CNRO-2004-00014

**SUBJECT:** Request for Alternative ANO1-R&R-006 -  
Proposed Alternative to ASME Weld Examination Requirements for  
Repairs Performed on Reactor Vessel Head Penetration Nozzles

Arkansas Nuclear One, Unit 1  
Docket No. 50-313  
License No. DPR-51

**REQUEST FOR ALTERNATIVE  
ANO1-R&R-006, Rev. 0**

**FIGURE 1**  
**New ANO-1 RPV Head Nozzle**

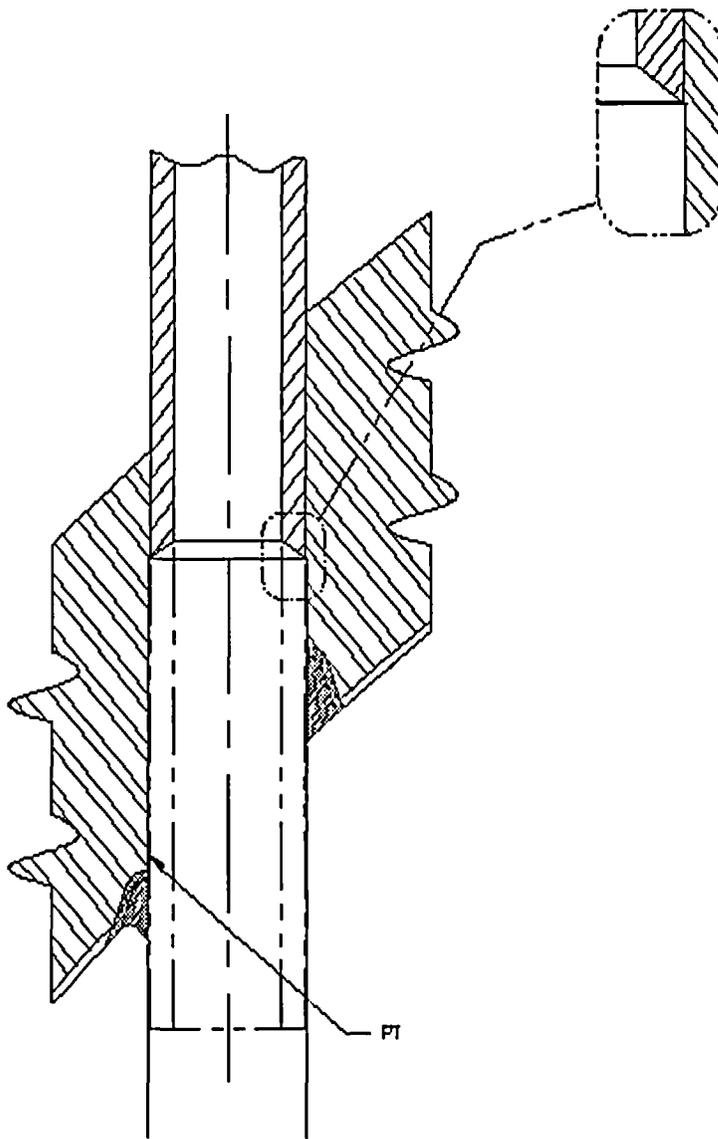
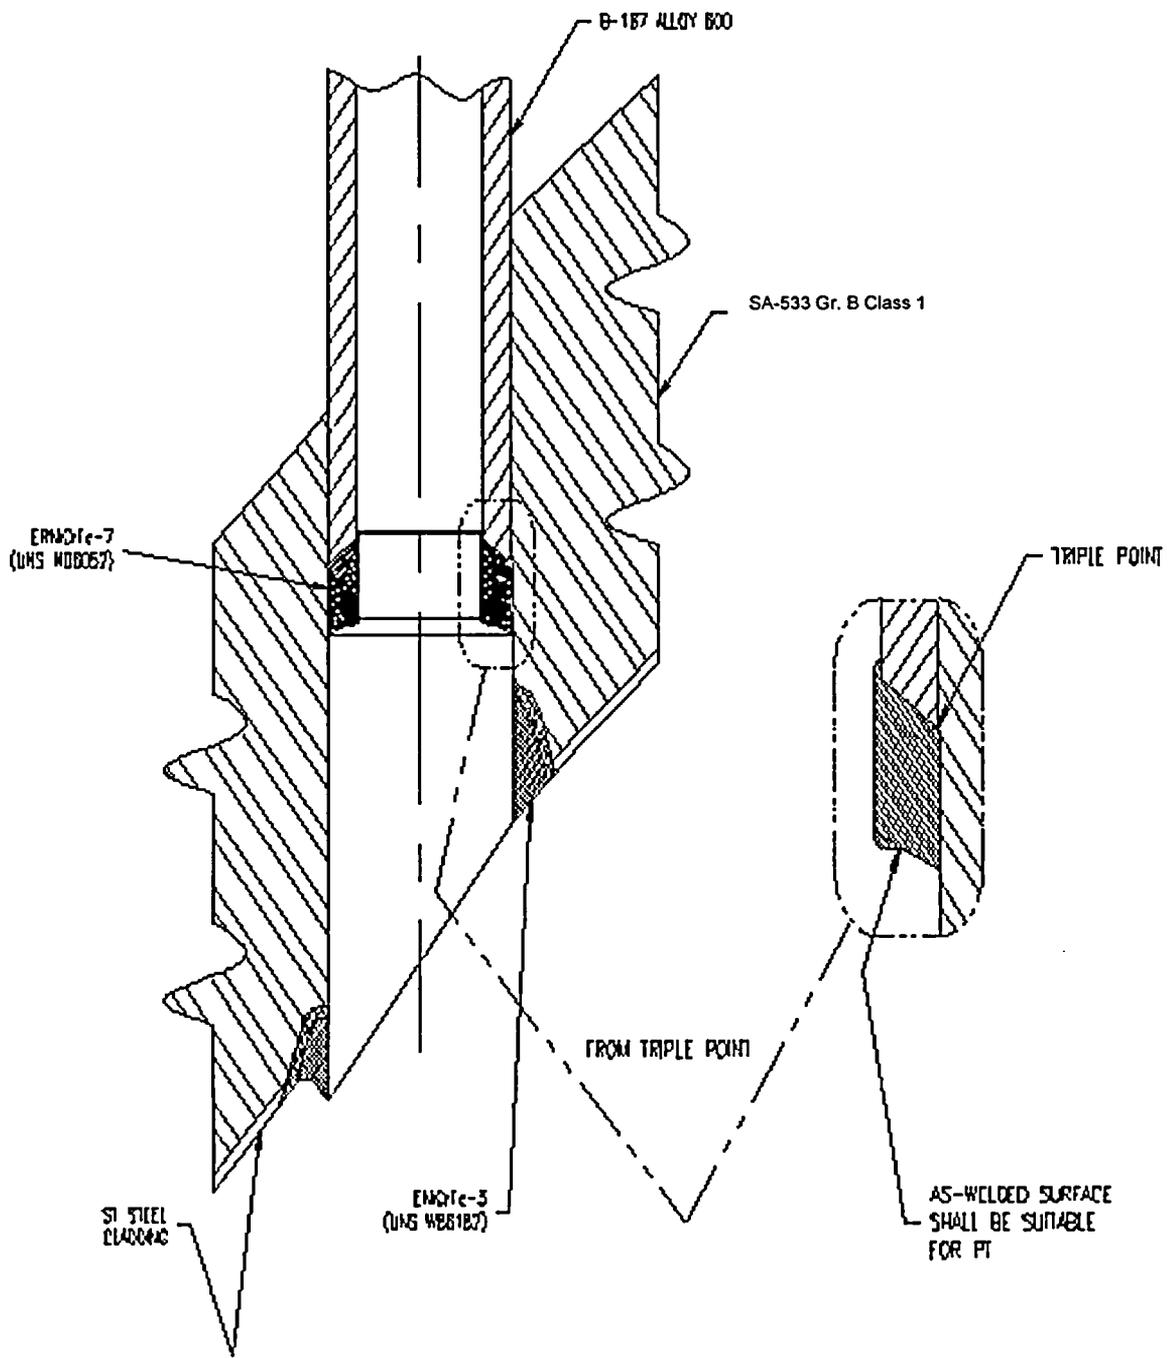
The original nozzle-to-RPV head weld configuration is extremely difficult to UT due to the compound curvature and fillet radius as can be seen in Figures 1 and 2. These conditions preclude ultrasonic coupling and control of the sound beam in order to perform flaw sizing with reasonable confidence in the measured flaw dimension. Therefore it is impractical, and presently, the technology does not exist, to characterize flaw geometries that may exist therein. Not only is the configuration not conducive to UT but the dissimilar metal interface between the Ni-Cr-Fe weld and the low alloy steel RPV head increases the UT difficulty. Furthermore, due to limited accessibility from the RPV head outer surface and the proximity of adjacent nozzle penetrations, it is impractical to scan from this surface on the RPV head base material to detect flaws in the vicinity of the original weld. Entergy proposes to accept these flaws by analysis of the worst case that might exist in the J-groove. Since the worst case condition is to be analyzed as described below, no future examinations of these flaws is planned.
